## STATE OF WASHINGTON DEPARTMENT OF SOCIAL AND HEALTH SERVICES

TO: RFQQ #09-360 Bidders

SUBJECT: Amendment #2 – Bidder Questions & DSHS Answers

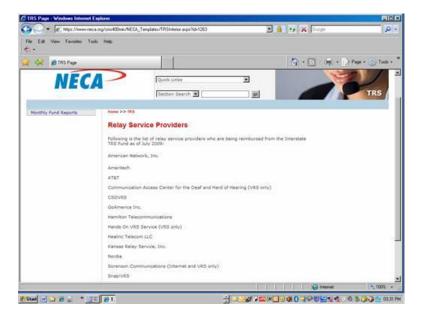
RFQQ Page 3, Section 1.3.2 Captioned Telephone Relay Service requires Proposers to submit an email from the NECA fund administrator stating that they are approved to receive reimbursement for interstate and 2-line captioned telephone calls. Is the following screen shot of the NECA website listing the Proposer as a Relay Service Provider acceptable as reimbursement proof?

**DSHS Answer**: Bidders shall submit a copy of official documentation or email correspondence from either NECA or the FCC in response to the requirement of this section of the RFQQ. The NECA website would not be an appropriate response to the RFQQ.
